**ZONING AMENDMENT,
PLANNED UNIT DEVELOPMENT &
SUBDIVISION STAFF REPORT**

Date: March 5, 2009

<u>NAME</u>	Kentress Morrisette
<u>SUBDIVISION NAME</u>	Booker T. Washington Highlands Subdivision, First Addition, Block F, Resubdivision of Lots 8 & 9
<u>LOCATION</u>	Southeast corner of First Avenue and Prince Street
<u>CITY COUNCIL DISTRICT</u>	District 1
<u>PRESENT ZONING</u>	R-1, Single-Family Residential
<u>PROPOSED ZONING</u>	R-3, Multiple-Family Residential
<u>REASON FOR REZONING</u>	Changing conditions in the area
<u>AREA OF PROPERTY</u>	1 Lot / 0.3± Acre
<u>CONTEMPLATED USE</u>	<p>Subdivision approval to create 1 legal lot of record, Planned Unit Development Approval to allow two apartment buildings on a single building site, and Rezoning from R-1, Single-Family Residential, to R-3, Multiple-Family Residential, to allow an eight-unit apartment complex.</p> <p>It should be noted, however, that any use permitted in the proposed district would be allowed at this location if the zoning is changed. Furthermore, the Planning Commission may consider zoning classifications other than that sought by the applicant for this property.</p>

SITE PLAN

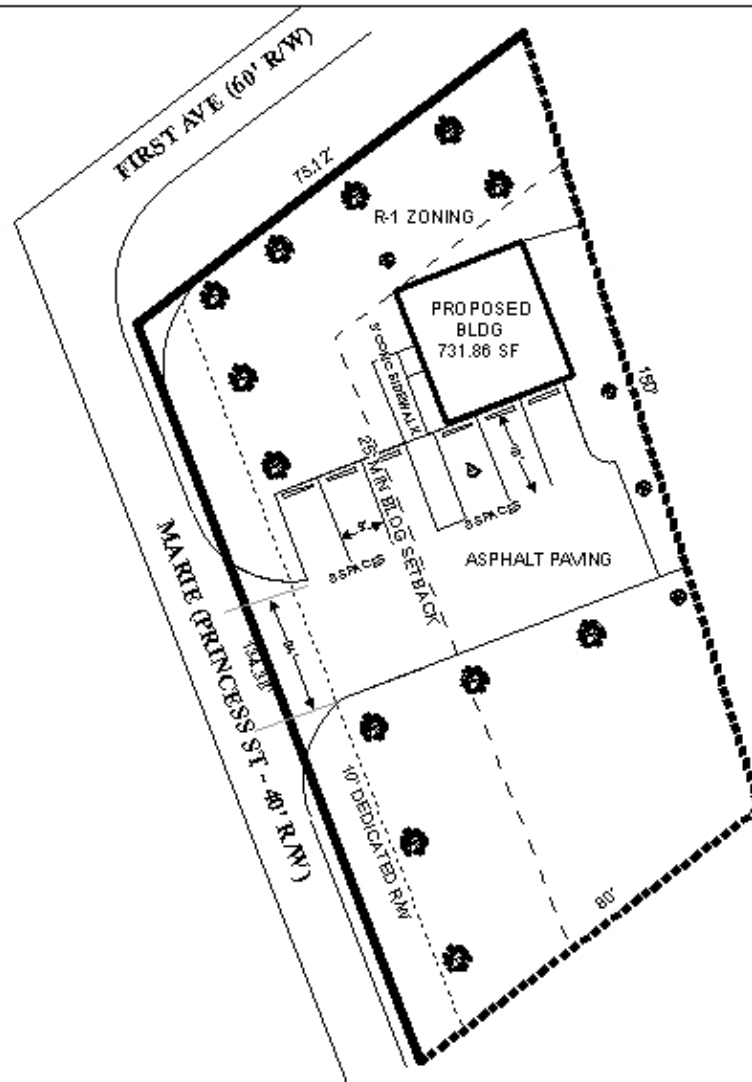
The applicant proposes an eight-unit apartment complex consisting of two buildings. The site is proposed to hold 12 parking spaces, the minimum amount required as per the Zoning Ordinance. The applicant proposes to access the parking area from Prince Street, which does not appear to meet City of Mobile standards. Considering the traffic generated by an eight-unit apartment complex, no development of this PUD should be allowed until such time that Prince Street is brought up to City of Mobile standards.

The southernmost building is located within the required side yard. A side yard setback of at least eight feet is required in an R-3 zoning district. Additionally, for an eight-unit apartment complex, a minimum lot area of 17,000 square feet is required (8,000 for the first two units plus 1,500 square feet for each additional unit). The site only contains 12,945 square feet, which does

meet requirements. In fact, a 12,945 square foot site would only contain enough area to allow a five-unit apartment complex.

No buffers are shown between this site and the neighboring single-family residential areas. A buffer in compliance with 64-4.D.1 of the zoning ordinance would be required where the site abuts a single-family residential district.

The proposed lot meets the minimum size requirements as regulated by Section V.D.2 of the Subdivision Regulations. The proposed lot size is not indicated on the plat and labeling of the lot with the size in square feet, or provision of a table with the same information, should be provided.

The site fronts First Avenue to the North and Prince Street to the West. Prince Street is incorrectly labeled as Marie (Princess Street). The plat should be modified to reflect the name Prince Street. First Avenue is a minor street with an adequate 60-foot right-of-way. Prince Street is a minor street not provided with curb and gutter. The Subdivision Regulations require a right-of-way of 60 feet for this type of street. However, the 1997 rezoning approval for the property directly West and across Prince Street from this site only required a dedication sufficient to provide 25 feet from the centerline, thus a 50-foot right-of-way. Because of this, dedication sufficient to provide 25 feet from the centerline of Prince Street is all that should be required. This dedication is depicted and should be retained on the final plat. Compliance with Section V.B.16 of the Subdivision Regulations regarding curb radii will also be required.

Due to limited frontage on First Avenue and Prince Street, the site should be limited to one curb cut to First Avenue or one curb cut to Prince Street.

- 1) Labeling of the lot with the size in square feet, or provision of a table with the same information;
- 2) Dedication sufficient to provide 25 feet from the centerline of Prince Street;

- 3) Compliance with Section V.B.16 of the Subdivision Regulations regarding curb radii;
- 4) Labeling of Prince Street as such on the final plat;
- 5) Placement of a note on the final plat stating that the site is limited to one curb cut to First Avenue or one curb cut to Prince Street;

- 6) Retention of the 25-foot minimum building setback line;
- 7) Show the minimum FFE and location of flood zones on the plat;
- 8) Placement of a note on the final plat stating that approval of all applicable federal, state and local agencies will be required prior to the issuance of any permits; and
